**QUEENSLAND WATER RESOURCES COMMISSION  
TOWN WATER SUPPLY AND SEWERAGE BRANCH**

**OF FLOODING IN FLAT ROCK CREEK**

**JOB No. F.M. 242**

**JANUARY 1982**

FIGURE 1: FLAT ROCK CREEK LOWER CATCHMENT

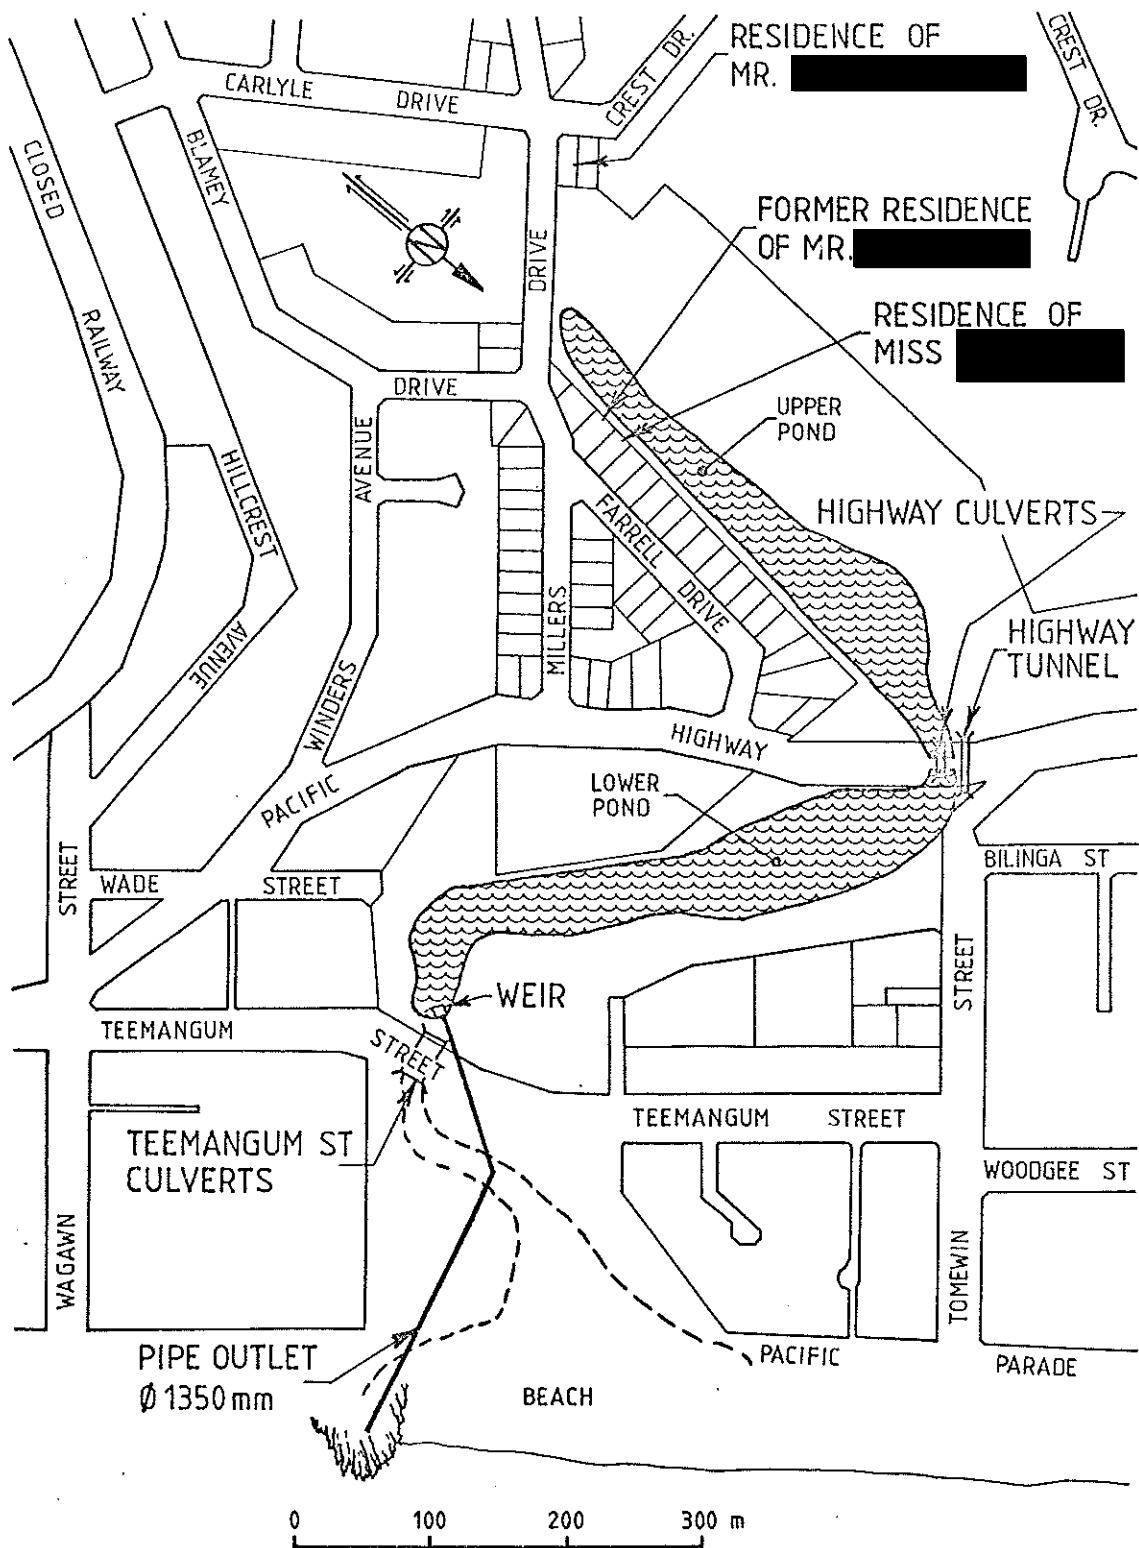
The flooding problem in Flat Rock Creek occurs in that reach of the Creek flanked by the Currumbin Bird Sanctuary. This reach consists of two ponds or lakes, the upper ("upstream" or "western") pond and the lower ("downstream", "eastern" or "Sanctuary") pond, which are separated by the Pacific Highway. The lower pond is separated from the Pacific Ocean by Teemangum Street and Currumbin Beach. Figure 1 is a plan of the area.

The upper pond has always flowed into the lower pond through culverts under the Pacific Highway, though in times of flood the waters have, on some occasions and for different reasons, flowed over the roadway surface.

The upper pond, before 1967, was also tidally connected through the lower pond. Subsequent to 1969<sup>1</sup>, the tidal connection was broken, but the upper pond still flowed into the lower pond under the Gold Coast Highway. From 1967 to 1973, this connection was through 3 No. 2700 x 1500 RCBC's<sup>2</sup> (a total cross-sectional area of 12.15 m<sup>2</sup>) at an approximate invert level of 0.6 m AHD<sup>3</sup>. After 1973, the connection consisted of 4 No. 1200 RCPs (a total
